CITY OF PATASKALA PLANNING & ZONING COMMISSION

STAFF REPORT

TCOD Application TCOD-21-004

TCOD-21-004 Staff Review

SP-1

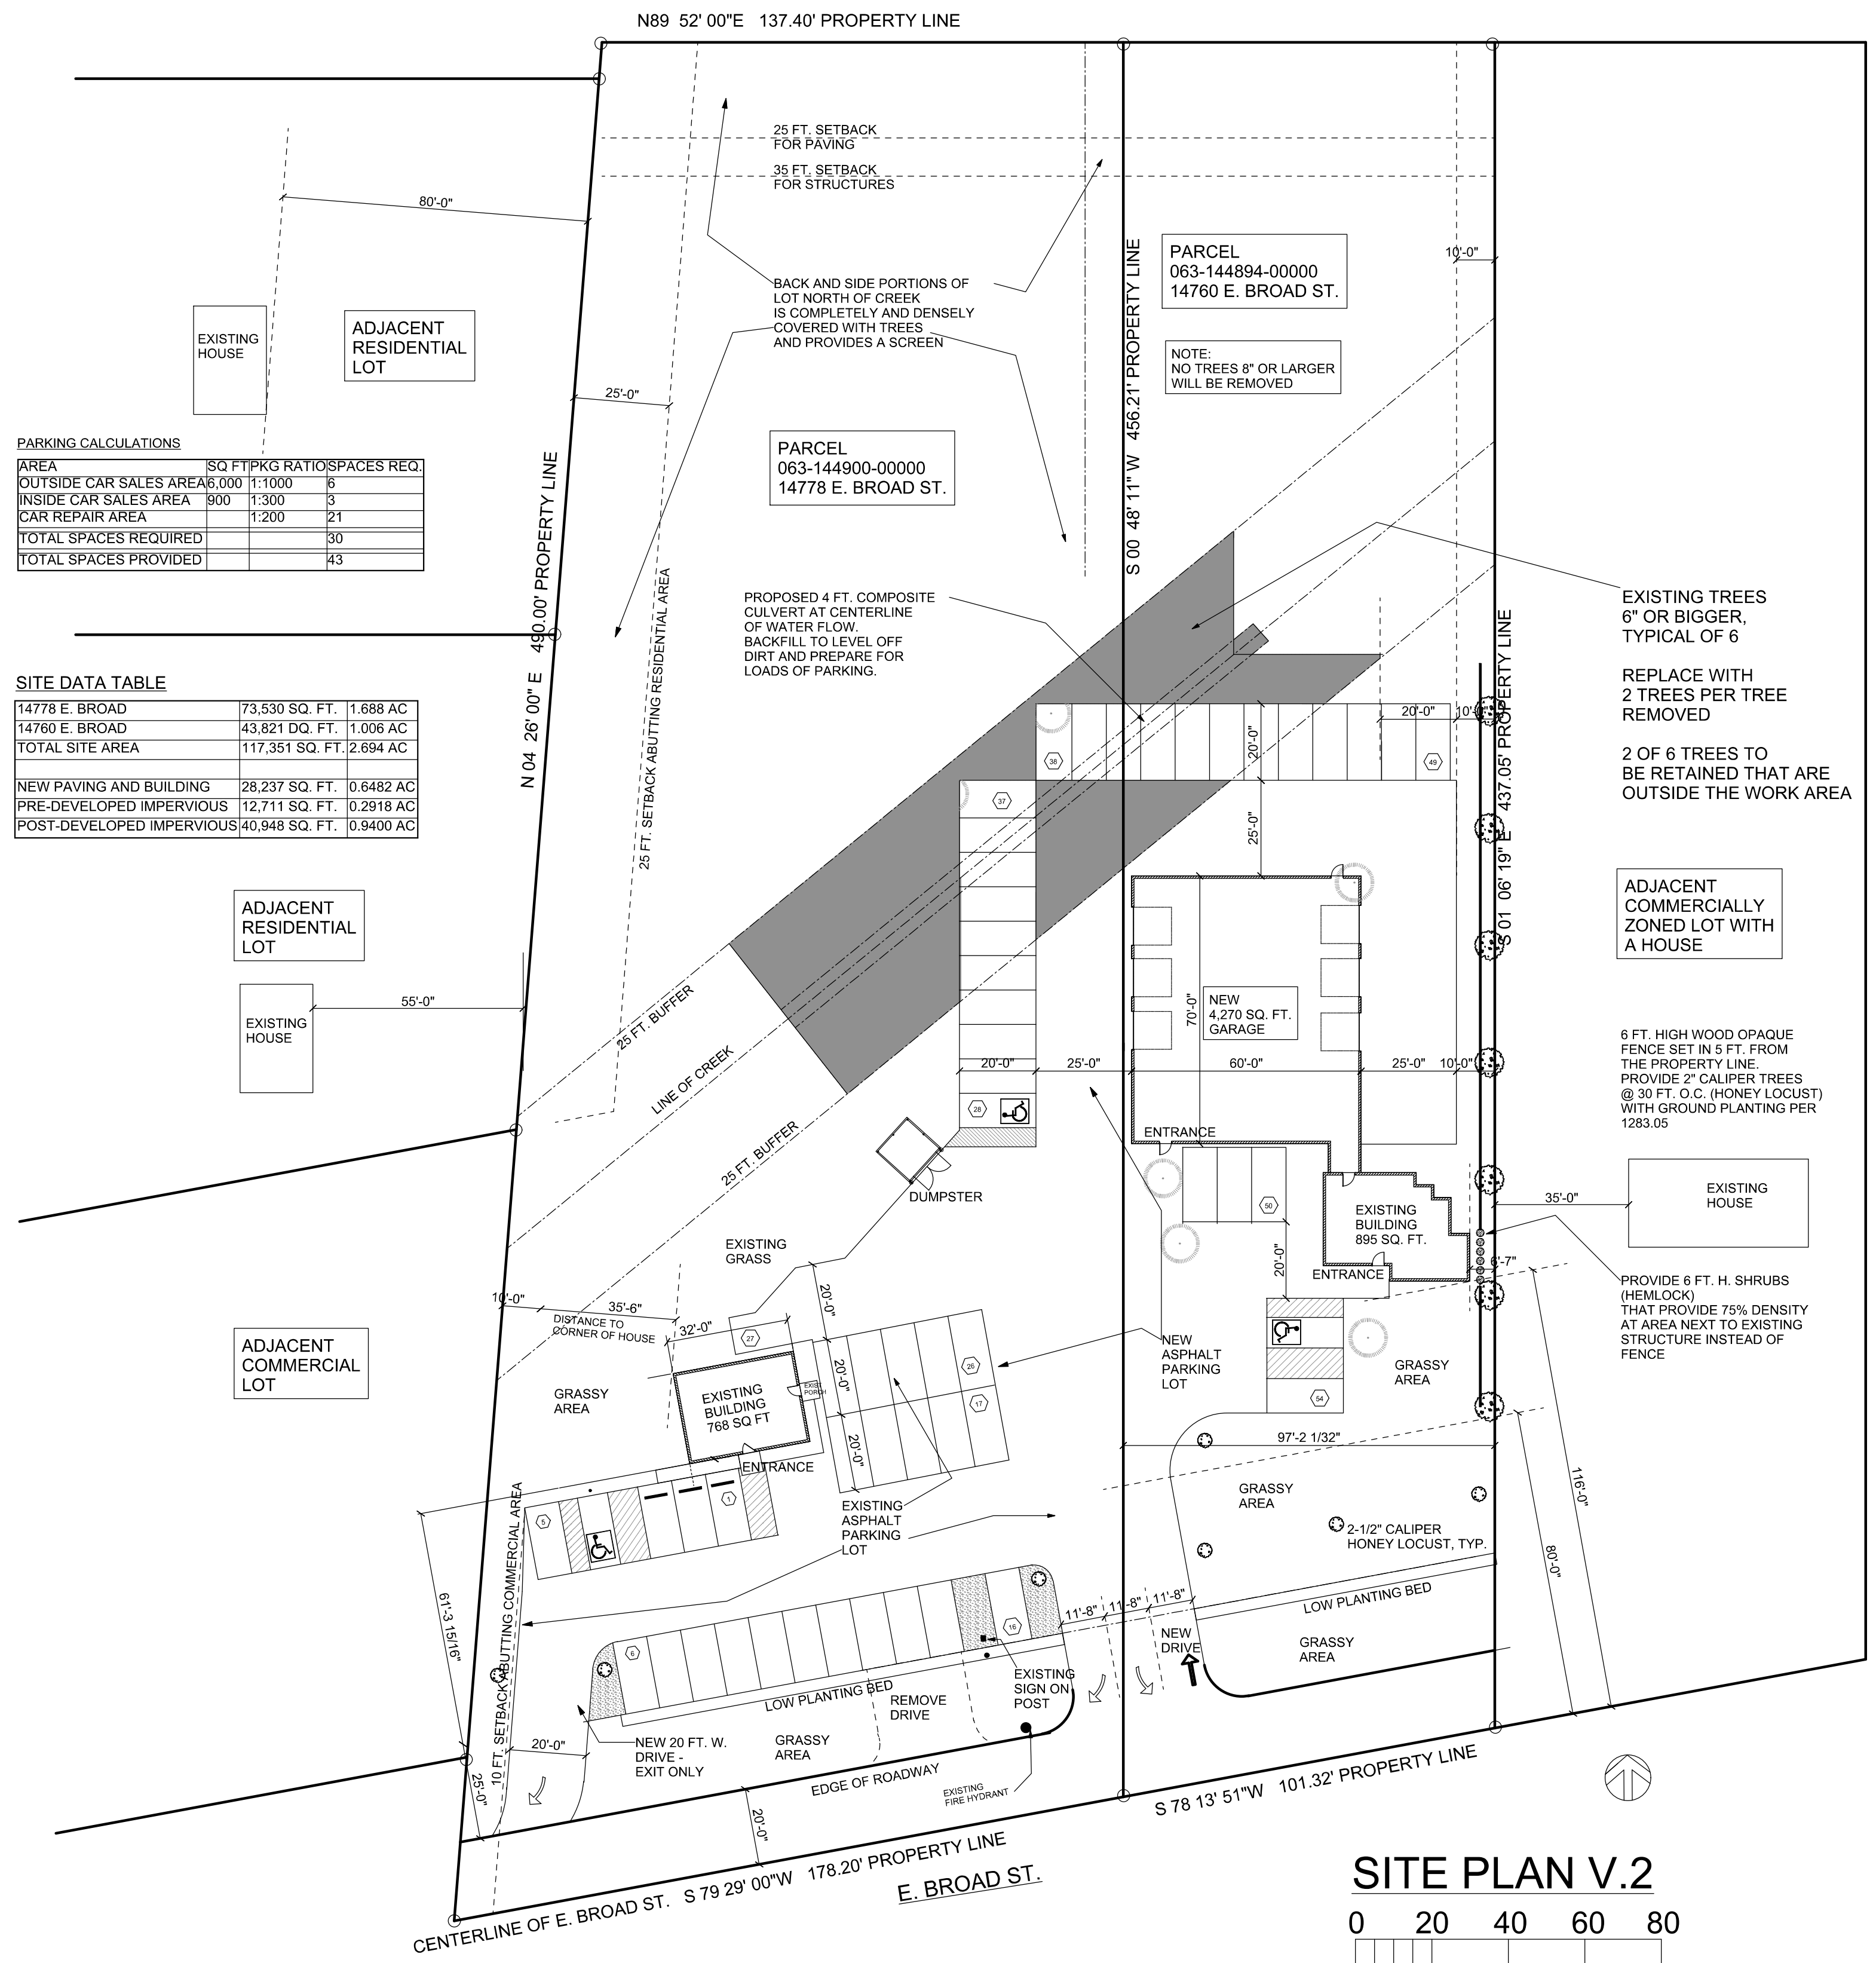
There are several comments listed in the attached review that Staff would like to see additional information on. The front yard setbacks as provided on the Site Plans are incorrect as they are measured from the centerline of the road. Pursuant to Section 1259.05(B) of the Pataskala Code The front yard setback shall be based on the recommended right-of-way width as outlined in the Master Thoroughfare Plan. For E Broad Street, this is a right-of-way width of 120-feet, or 60-feet on either side from centerline. Although this would put a portion of the property owner's existing parking within the Right-of-way the Public Service Director indicated this would be acceptable as it is preferable to obtain the additional right-of-way now, as opposed to having to come back and get it later.

Section 1291.03 of the Patsakala Code requires that any nonresidential parking area with 10 or more off-street parking spaces shall be illuminated during periods of darkness to provide an average intensity of ½ foot candles of light at the parking surface. No details on the proposed lighting were included.

There are many coded notes present on the Site Plan, however, there is no corresponding legend detailing what these identify. Staff would like to see this legend included. Additionally, Staff would like to know if the office use of the existing 768-square foot building is being retained, and what the use of the existing 895-square foot building will be.

There are a few items that differ from what is required per the code. First, with the landscaping. The rear perimeter requires L3 or L4 if abutting a residential use, which it does. Side yards required L3 or L4 if abutting a residential use as well, which it does on the east and part of the west. The Applicant is intending to use the existing vegetation to the north of the creek as screening from the adjacent unlike uses. Planning and Zoning Commission has the ability to approve the landscaping as proposed. However, Staff would like a note placed on the plans stating that the forested area in the rear, excepting the grey shaded area to be disturbed by the piping-in of the creek, shall be left as-is and in a natural state. No trees are to be removed unless dead or diseased, and should the area be cleared appropriate perimeter landscaping per Pataskala Code shall be installed.

Additionally, the front landscaping proposed does not meet the L2 standard as required by Pataskala Code. L2 being a continuous 3-foot-high shrub screen (or mound) with one tree per 30 lineal feet. Only low planting beds are proposed. The Planning and Zoning Commission does have the authority to approve the landscaping as proposed. As mentioned above, the proposed setbacks will need to be adjusted to account for the additional Right-of-way. By moving the line back, the proposed additional parking area would be approximately 10-feet inside the required 40-foot parking area setback, however, the Planning and Zoning Commission does have the authority to approve the setbacks as proposed.

- i) **Proposed setbacks are based off centerline of road. Setbacks need to be measured from future Right-of-way line as required by 1259.05(B)**
 - ~~b) 1249.05(C)(2): Side Yard when abutting non-residential zoning district: 25-feet for structures, 10-feet for paved areas.~~

- i) **No detail on trash receptacle location/screening.**

- i) Front yard setbacks need adjusted to account for additional Right-of-way. This will likely put the new proposed parking area within the 40-foot parking setback. However, PZC has the right to approve as proposed.

- a) Note on plans stating some trees are to be removed and replaced at 1:2 ratio. Will need details on which trees are being removed, where they are being replaced, and what they are being replaced with. Note that trees being used for perimeter screening do not count towards replacement numbers.

(1) Low planting bed area identified but will need trees and shrubs to meet L2 otherwise obtain a waiver by PZC to approve as proposed.
 - b) Side Yard: L3 or L4 if abutting a residential use.

- i) New line of shrubs shown with Note 'F'. No details on height provided, would need to either meet requirements of L3 or L4 along the eastern property line. Note that the one tree every 30' is still required.

(1) East perimeter OK, will need PZC approval to use existing vegetation on west side.
 - c) Rear Yard: L3 or L4 if abutting a residential use.
 - i) Plan indicates that existing vegetation north of creek to be used as screening. Final approval up to PZC.

- 1) 1283.02(A)(7): A curbed landscaped island, minimum 6-feet in width, shall separate parking areas within a site from any entrance or exit to the parking lot.
 - ~~a) Cross-hatched area on site plan between entrance drive and parking lot should be curbed islands.~~
 - ~~b) Area of new blacktop in the northwest corner of the expansion, where it meets the existing blacktop; what will this be? Parking? Display area? Curbs may be required.~~
 - c) A 6' curbed landscape island will be required at the end of the 10-space, two-row parking area west of the existing 768-square foot building.

- 1) 1291.07(B): Number shall be in compliance with ADA guidelines. Accessible spaces shall be a minimum of 11-feet wide and 19-feet deep, with a 5-foot wide access aisle on one side.
 - a) Length identified at 20', but width of space and access aisle is not.
- 2) 1291.07(B)(1-3): Proper signage shall be posted.
 - a) Place note on plan indicating "signage and markings pursuant to section 1291.07 of the Pataskala Code to be installed)

- 1) Figure 655-1: For 75-90 degree parking the minimum dimensions are 9-feet wide, 19-feet deep. Parking Space maneuvering (distance between two opposing lanes of parking) shall be minimum of 20-feet.
 - a) Length ok at 20', width not identified.

- 1) 1291.13(1): All surface parking areas with more than 10 spaces shall provide curbed interior landscaping complying with one or a mix of the standards set forth below:
 - a) 1291.13(1)(a): Option 1 - Interior landscaping shall be provided at the rate of 20 square feet per stall. At least one tree must be provided for every 200 square feet of landscaped area. Ground cover plants as listed in Chapter 1283 must completely cover the remainder of the landscaped area
 - b) 1291.13(1)(b): Option 2 - One tree must be provided for every four parking spaces. The tree planting area must have a minimum dimension of 25 square feet. All island trees shall be protected from potential damage by vehicles.
 - i) It appears interior landscaping is provided, but details on the type of interior landscaping are not present. Need more information.

- 1) 1291.16(Commercial)
 - ~~a) The required number of parking spaces is calculated by the gross square footage of the building(s), so we will need to know the square footage of the existing/proposed structures.~~
 - b) The required number of parking spaces (for customers) for vehicle sales and service is 1 for each 300-square feet of indoor gross floor area, plus 1 per 1,000-square foot of outdoor display area. Mark out the areas intended for display of vehicles for sale.
 - i) SF of interior area: $(768+895+4,270 = 5,933) / 300 = 20$ spaces
 - ii) Outdoor display area SF : $6,000 / 1000 = 6$ spaces
 - iii) Total required: 26
- (1) Provided = 43 but the calculations in the table are incorrect.

1. There are a lot of coded notes on these plans, but there is no corresponding legend identifying what these coded notes mean. Please include the legend, or, if the coded notes are inconsequential to the TCOD application, remove them for the time being.
2. Will the existing building on 14778 E Broad Street be retained as an office? What will be the purpose of it and the existing house at 14760 E Broad Street.
3. There have been issues in the past (not this location) where auto sales and service uses park vehicles all over the place, blocking entrances and exits. All vehicles on the site must be parked within a designated space.
